TITLE: [PR-PC] Development Application DA13/0654 for a Two Lot Subdivision, Remove Existing Dwelling and Construct Two Single Dwellings - Staged Development at Lot 7011 DP 1065741 Marine Parade, Fingal Head and Lot 367 DP 755740 No. 40 Queen Street, Fingal Head

FILE REFERENCE: DA13/0654 Pt2

Having regard to relevant statutory controls, the proposed two lot subdivision, removal of existing dwelling and construction of two single dwellings is not considered suitable for the location and therefore the proposed development is recommended for refusal.

Figure 17: extract from WD 100.02 (Shadow Diagrams 2 Rev B) – 7:00pm December 22

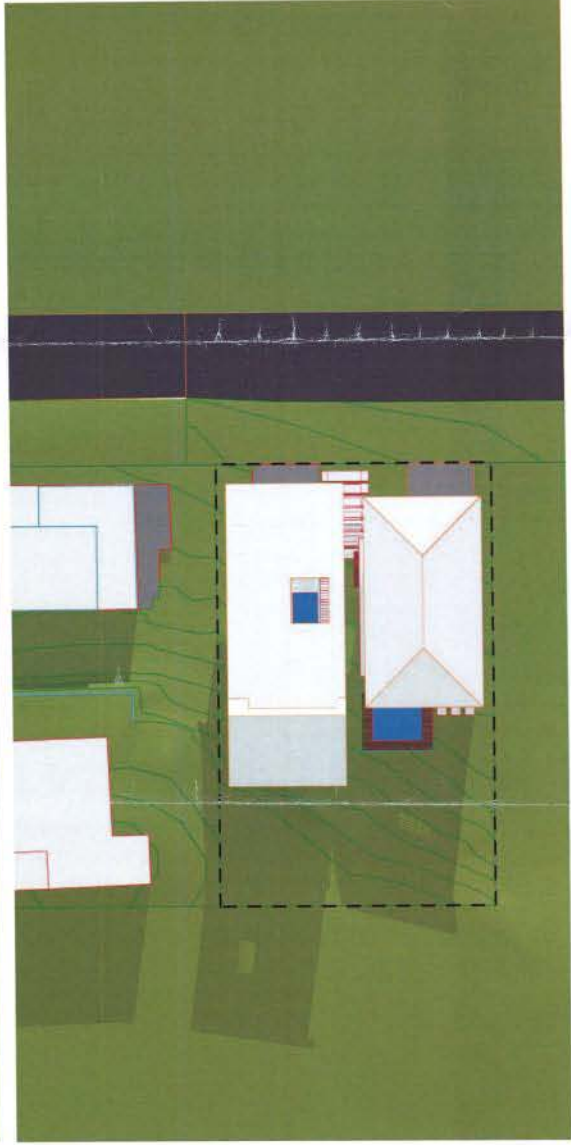
The SEPP No. 1 variation relates to Clause 32(b)(4)(b) of the NCREP which does not permit overshadowing of adjacent open space before 7pm midsummer (daylight saving time). Council has an instrument of assumed concurrence and it was therefore not necessary to refer the application to the Department of Planning and Infrastructure (DP&I) for concurrence purposes.

- Unacceptable impact on an Endangered Ecological Community located on the site;
- Overshadowing of Crown land managed by Council for coastal environmental protection purposes;
- Inconsistency of dwelling designs with DCP A1 controls for residential development.

Figure 20: excerpt from Site Plan WD 0.03 Rev C – adjoining existing development at 42 Queen Street

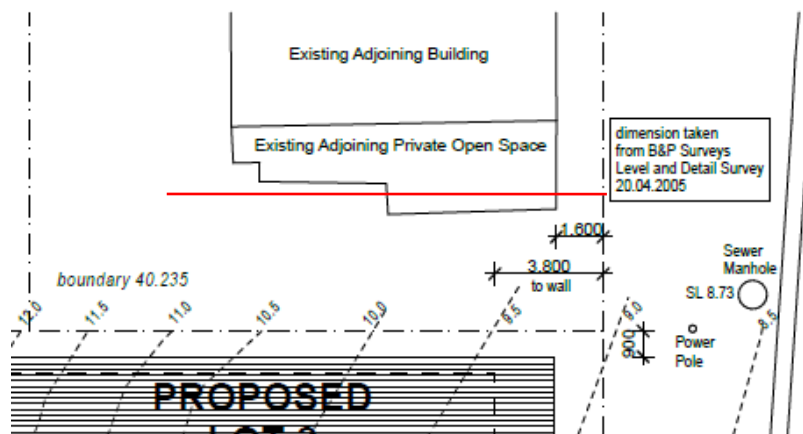
The edge of the existing verandah is setback 4m at its closest point and 5.8m at its farthest point. The horizontal line across the verandah (above) represents an approximate setback of 5.5m. This will be the new building line as approved by DA13/0584.

Overshadowing is intensified with regard to the approved plans for 42 Queen Street in that windows to the living areas are unlikely to receive at least three hours of sunlight between 9am and 3pm on June 21 which is also inconsistent with Control C4:

Figure 30: extract from Site Plan WD 0.03 Rev B – Tree Removal

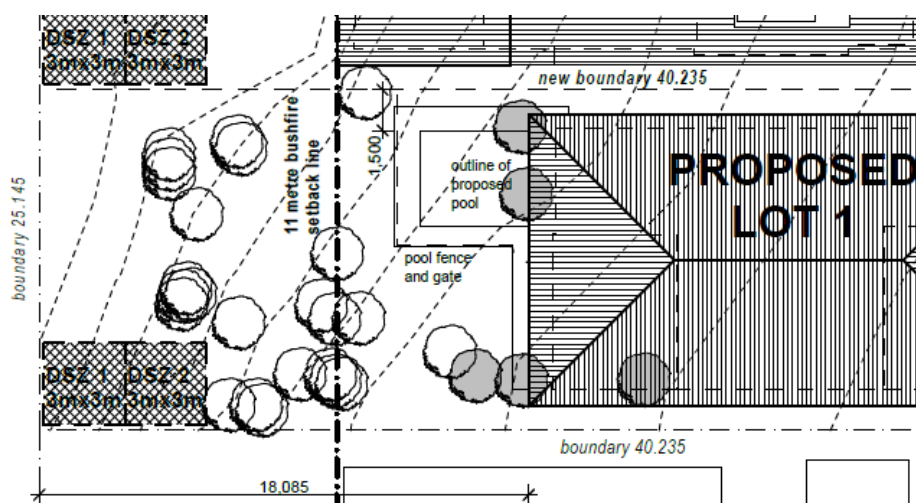
Page 11 of the EA concludes that four trees comprising part of the EEC would be required to be removed to facilitate the development. However, page 17 of the EA indicates that five trees have been identified for removal which is consistent

The loss of four to five trees necessary to establish the proposed dwellings has been estimated at 80m² of Littoral Rainforest. This would appear to be inaccurate as the report clearly does not consider modification of the community for bushfire hazard mitigation purposes.

As previously discussed, two stems of two listed species were not identified on submitted plans or within the EA. Page 10 of the EA suggests that 'several individuals of White Lace Flower (*Archidendron hendersonii*)' were recorded yet only one was shown on the plan.

Figure 31: Vegetation Community Map (Page 13 of EA – Figure 7)

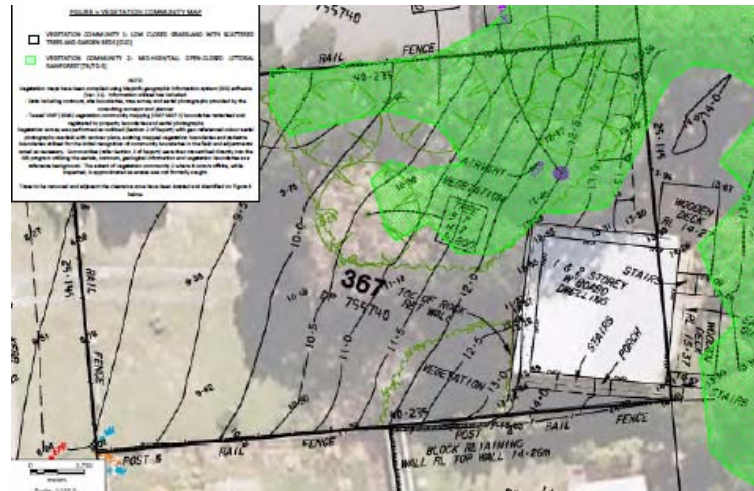
Furthermore, the extent of *Vegetation Community 2: Mid High/Tall Open-Closed Littoral Rainforest* depicted above in Figure 7 of the EA (Vegetation Community Map) is considered to be imprecise following site inspection, as it does not account for the complete extent of the Littoral Rainforest canopy. Even in the case where disturbance for bushfire management purposes is not required the area of 80m² disturbance is an underestimate.
